IMPORTANT RECALL INFORMATION #70806

SUBJECT: RECALL CAMPAIGN #70806
Prowler, Terry, Wilderness
Manufacturer Federal Certification Tags

Recall Bulletin 70806

SUBJECT:
Replacing the
Manufacturer
Federal
Certification
Tag

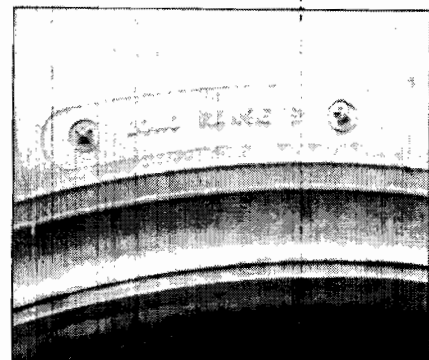
Fleetwood Enterprises, Inc. has become aware of a possible tire pressure rating error on the Travel Trailer Manufacturer Federal Certification tag. The 10-ply tires originally supplied with the travel trailer and rated "Load Range E", require tire inflation pressures of 80 PSI (pounds per square inch). The Certification tags were printed with a tire pressure rating of 65 PSI. The tire air pressure rating, printed on the Certification tag, must correspond with the Load Range of tires currently installed on the travel trailer.

1. Verify that the tires on your travel trailer are stamped "Load Range E", as shown in the photograph at right.
2. Locate the original Travel Trailer Manufacturer Federal Certification tag, located on the forward road-side exterior of the travel trailer. Wipe off any dirt or debris with a clean, dry cloth. Mark out the information printed on the original Certification tag using a black permanent marker. Peel the backing off of the new Travel Trailer Manufacturer Federal Certification tag enclosed with this letter, and apply it directly over the original tag. The new tag should completely cover the original.
